SHELBY COUNTY
HIGHWAY DEPARTMENT
506 HIGHWAY 70
COLUMBIANA, ALABAMA 35051
(205) 669-3880
www.ShelbyAL.com

PROJECT NO. SCP 59-959-24
ADDENDUM NO. 2

TO: Prospective Bidders
FROM: Mark Endfinger, P.E.
Chief Engineer

PRECAST RAIL BLOCK TYPICAL SECTION

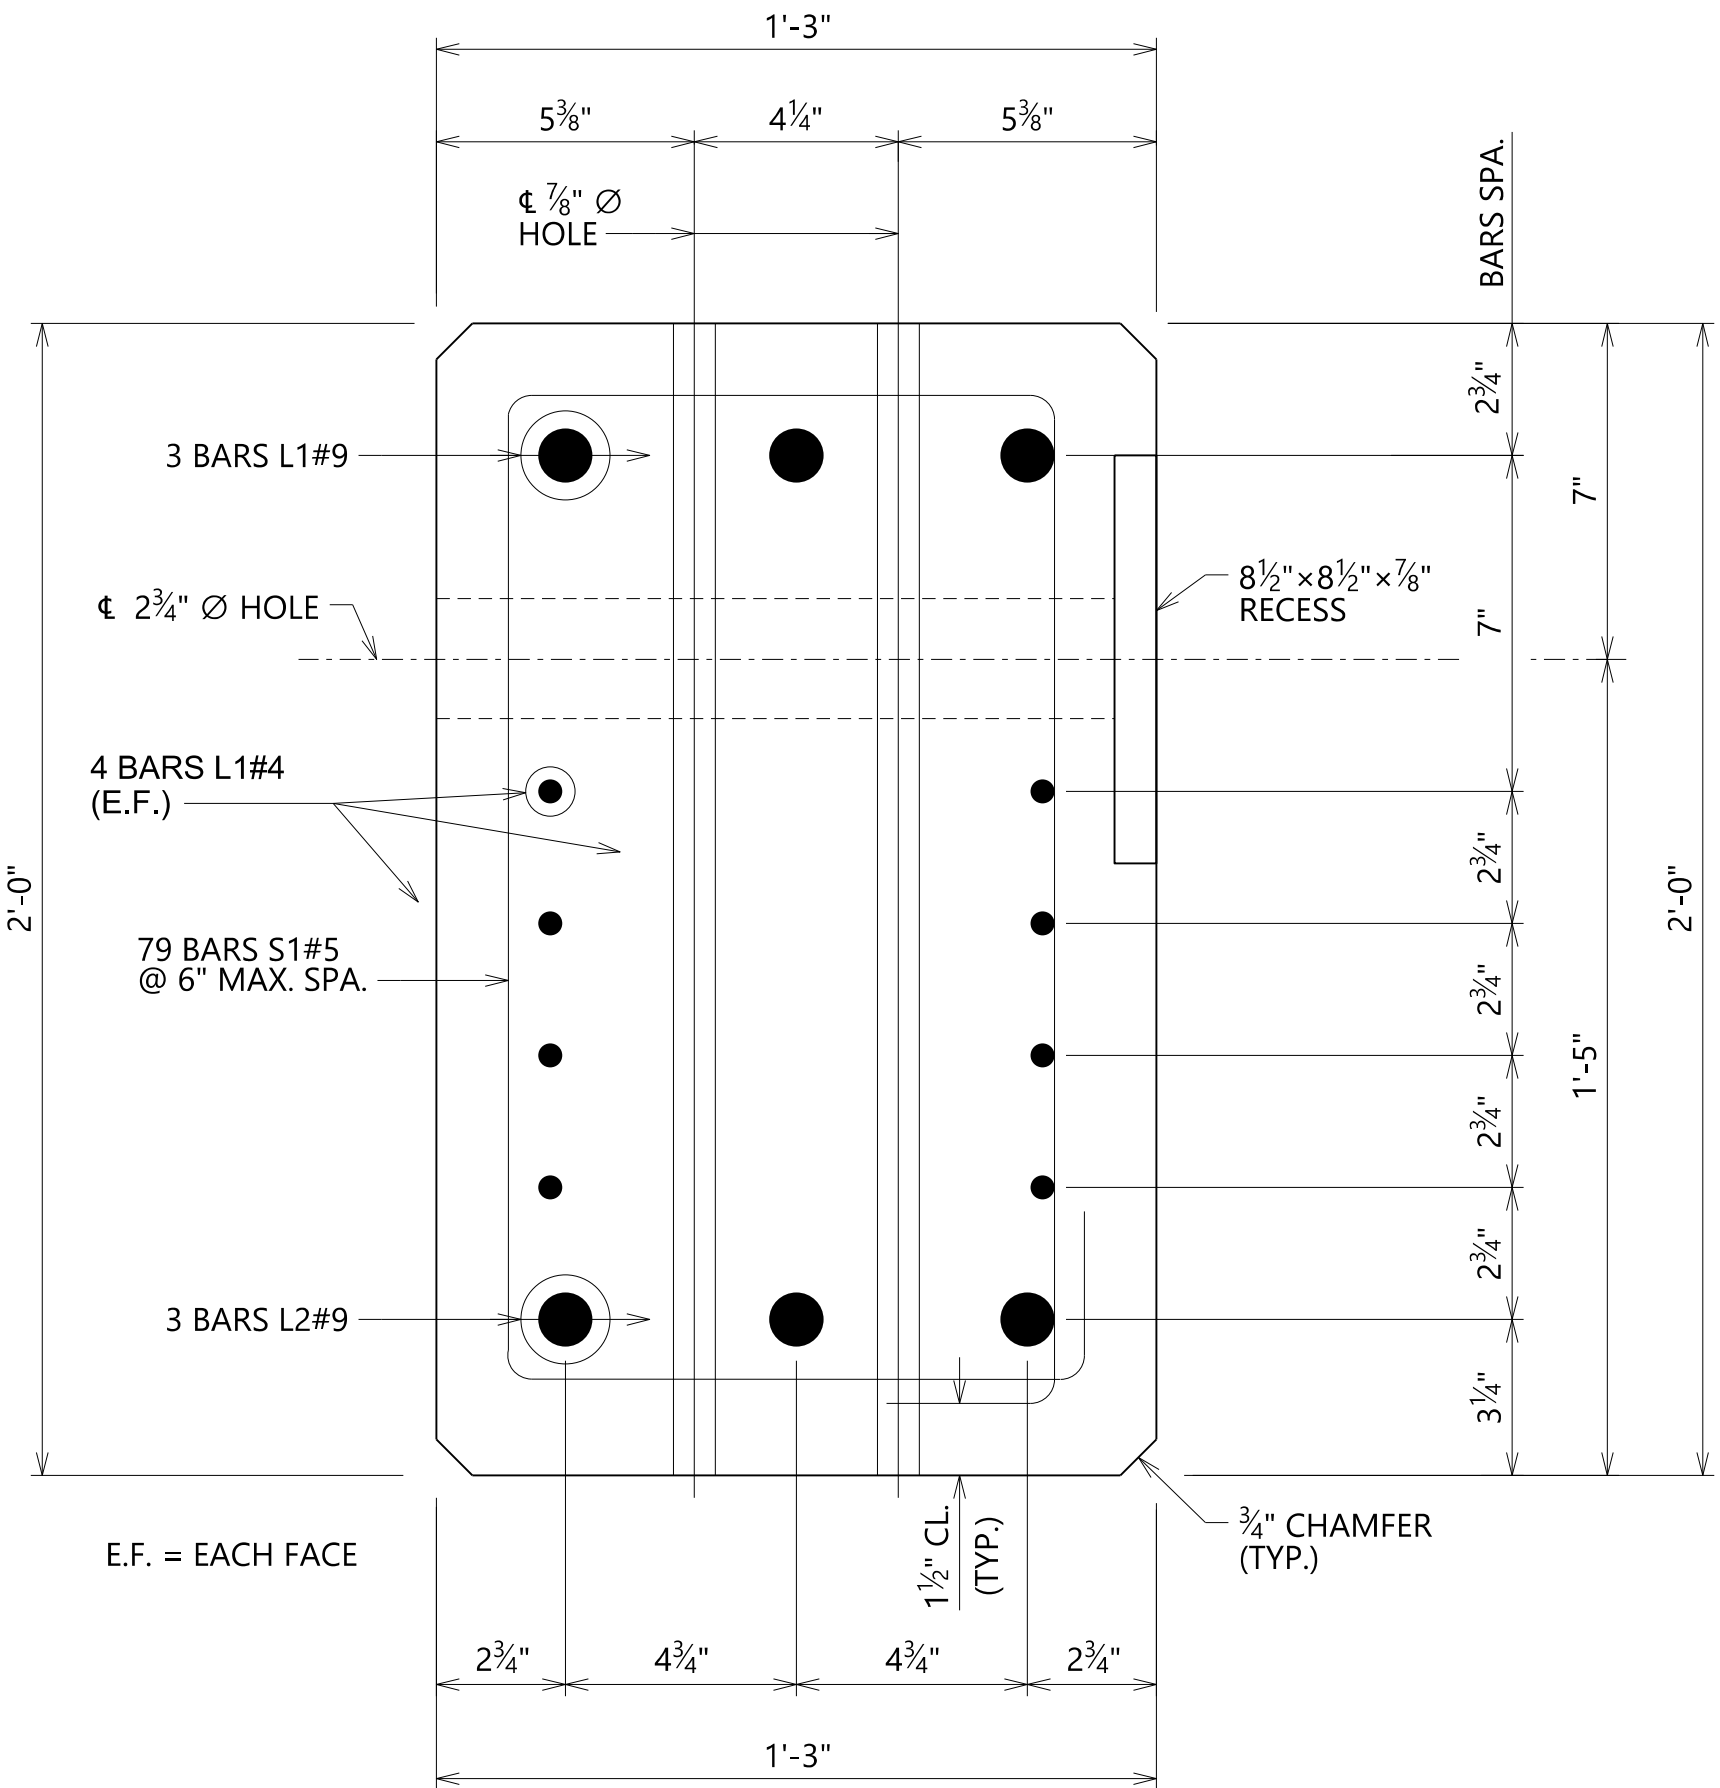
Q2 – Should the bottom 3 #4 bars in the rail block typical section on Sheet 64 be 3 #7 bars?

A2 – The typical for the precast rail block has been redesigned. Please see the revised typical on REVISED sheet 64 for the new design and reinforcement detail. The keyway for this block has been removed.
